**YARRA CITY COUNCIL**  
**Internal Development Approvals Committee**  
**Agenda**

**1.1 PLN17/1070 - 188 - 196 Gertrude Street, Fitzroy - Use and development of the land for a Restricted Recreation Facility (Gym), partial demolition, external alterations and the display of business identification signage.**

1. This report provides Council with an assessment of planning application PLN17/1070 at 188-196 Gertrude Street, Fitzroy for the use and development of the land for a Restricted Recreation Facility (Gym), partial demolition, external alterations and the display of business identification signage; and recommends approval subject to conditions.

**Figure 5:** Sketch plans produced by the applicant showing a reduction in the scope of the proposed signage.

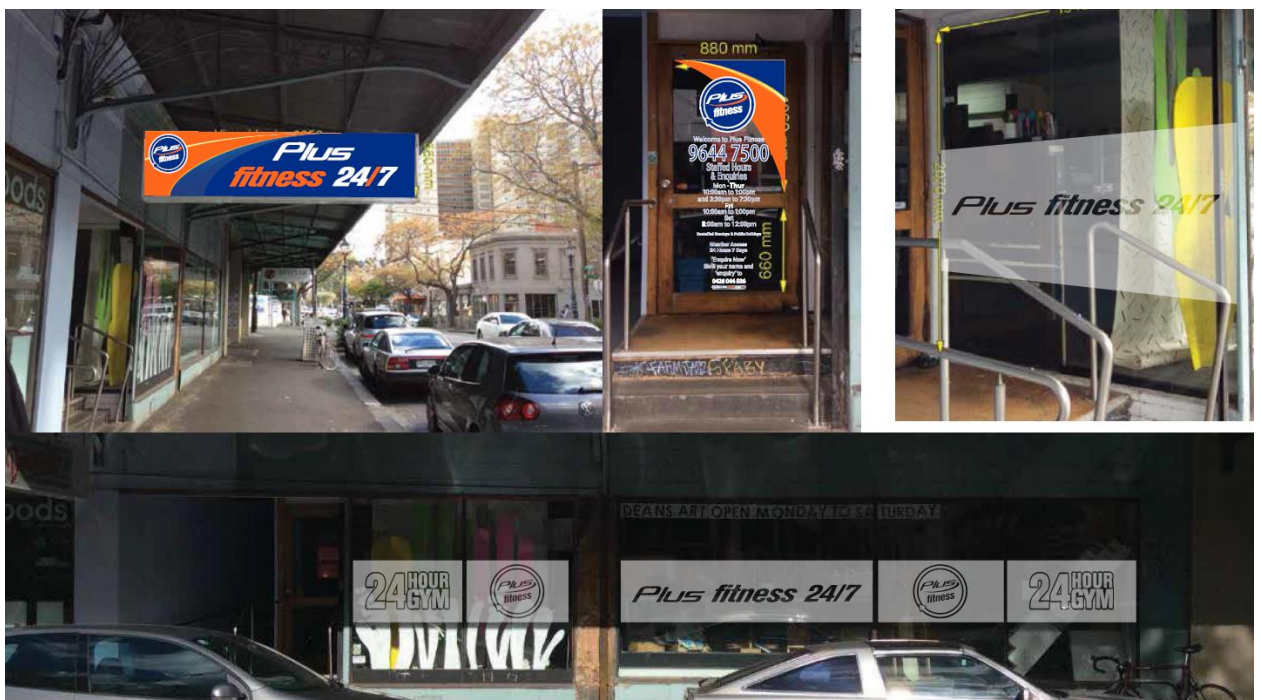
78. The revised signage scheme is considered to represent a significant improvement from the decision plan scheme, to an extent that the signage is no longer considered to detrimentally affect the significance of the heritage place. The sketch plans were shown to Council's Heritage Advisor who confirmed that they were an acceptable outcome from a heritage perspective. As such, the reduced scope of signage will be included as a permit condition, should a permit issue.

79. The sketch plans do not provide clear dimensions nor do they accurately show the proposed signage in accordance with the proposed external alterations. A further condition will require that the sketch plans are modified to provide these details, should a permit issue.

80. The Planning Officer has assessed the sketch plans, and whilst they do not provide dimensions, was able to roughly calculate that the total signage proposed under the sketch plans would exceed 8sqm (excluding the lightbox signage), thus continuing to require a planning permit under Clause 52.06-5 (Advertising Signs). In addition to being satisfactory from a heritage perspective, the sketch plan scheme is also considered to be acceptable when assessed against the relevant decision guidelines at Clause 52.05-3, specifically:

1. Before the use or development commences, amended plans to the satisfaction of the Responsible Authority must be submitted to and approved by the Responsible Authority. When approved, the plans will be endorsed and will then form part of this permit. The plans must be drawn to scale with dimensions, and three copies must be provided. The plans must be generally in accordance with the decision plans but modified to show:
  - (a) Front entrance ramp opening reduced in width to a maximum of 1.5m;
  - (b) Provision of at least 2 on-site bicycle spaces;
  - (c) Reduction in the scope of advertising signage in accordance with sketch plans produced by 'BannerShop' received by Council on 20 April 2018;

- (i) Signage in accordance with the proposed shopfront scheme as required by condition 1(a);
  - (ii) All signage fully dimensioned.
2. The use and development as shown on the endorsed plans must not be altered (unless the Yarra Planning Scheme specifies that a permit is not required) without the prior written consent of the Responsible Authority.
  3. The provisions, recommendations and requirements of the endorsed Acoustic Report must be implemented and complied with to the satisfaction of the Responsible Authority.
  4. The provisions, recommendations and requirements of the endorsed Management Plan must be implemented and complied with to the satisfaction of the Responsible Authority.

Proposed Business Identification Signage - 188 - 196 Gertrude Street, Fitzroy

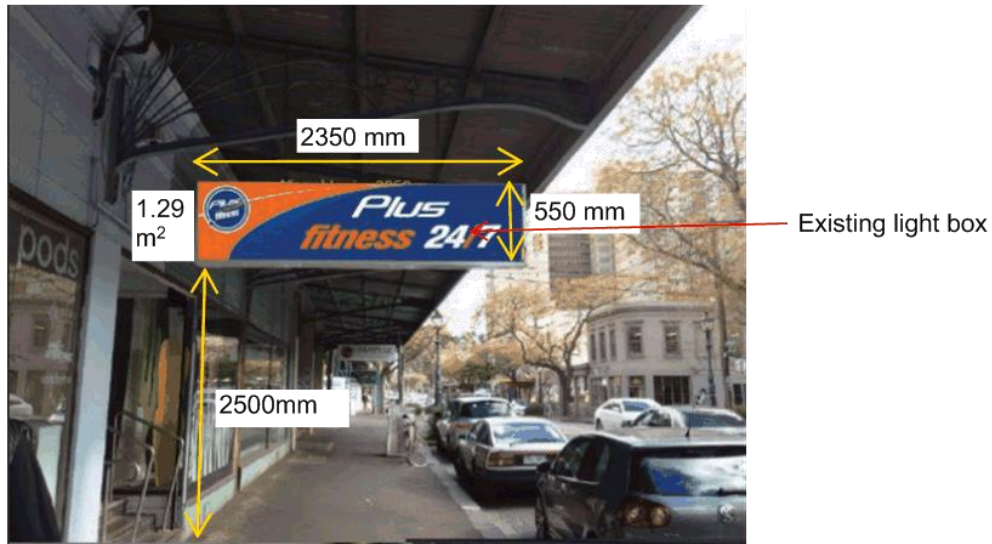
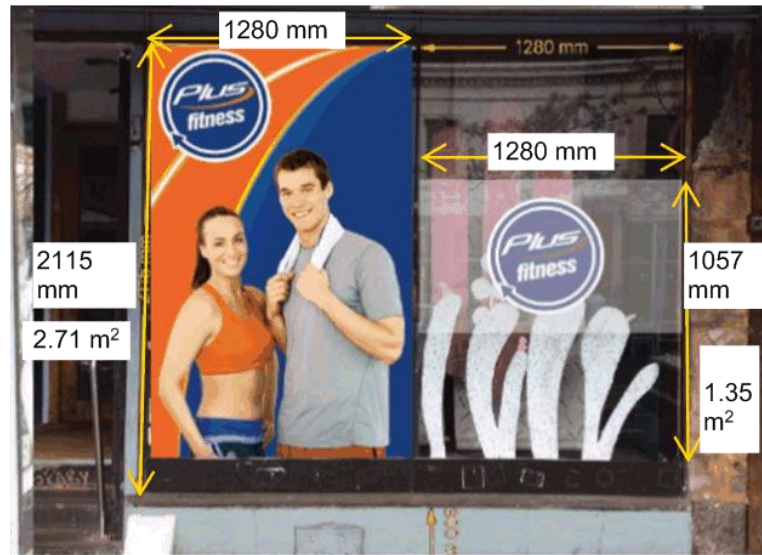
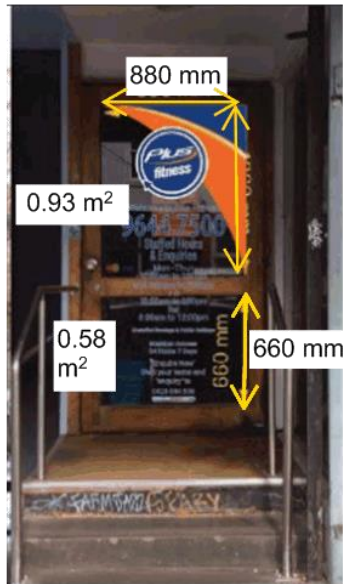
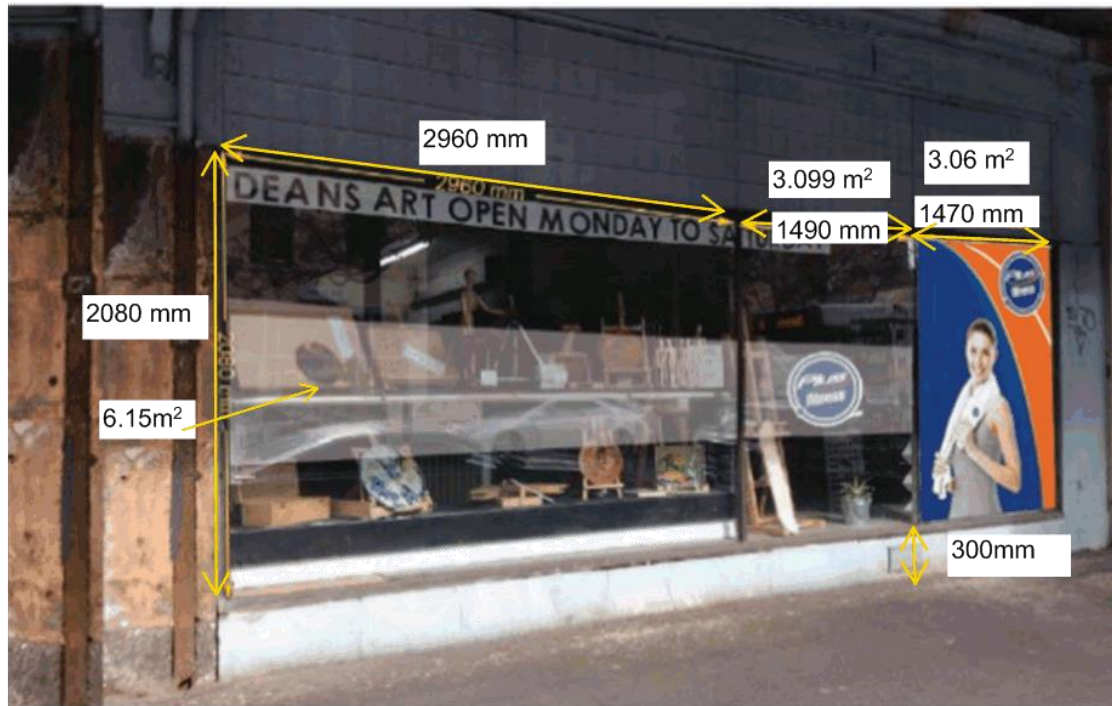
76. The application proposes to display a significant amount of signage along the Gertrude Street shopfront of the subject site, as shown at figure 4 below. Clause 22.04-3.8 (Advertising Signs Policy – Heritage Areas) directs that new signage in heritage areas should be small and restrained in size and that the number of new signs should be limited. The proposed signage is considered to be excessive both in terms of size and design. As such, it is considered that the proposed signage would detract from the significance of the heritage place. Council's Heritage Advisor shares this concern and stated that:

77. In response to the heritage advice received (as well as the concerns of objectors heard at the consultation meeting), the applicant provided sketch plans which significantly reduced the extent of signage, both in terms of size and design. An excerpt of the sketch plans have been provided below at figure 5. The revised signage scheme is limited to the following:
- Under-verandah, internally-illuminated business identification signage (to be located within an existing hanging lightbox) with business logo in bright orange and blue colours;
  - Business identification signage applied to the shopfront glazing (including the entrance return) with business logo, descriptive text and no colour;
  - Business identification signage applied to the glazing of the proposed front door with business logo, descriptive text and bright orange and blue colours.
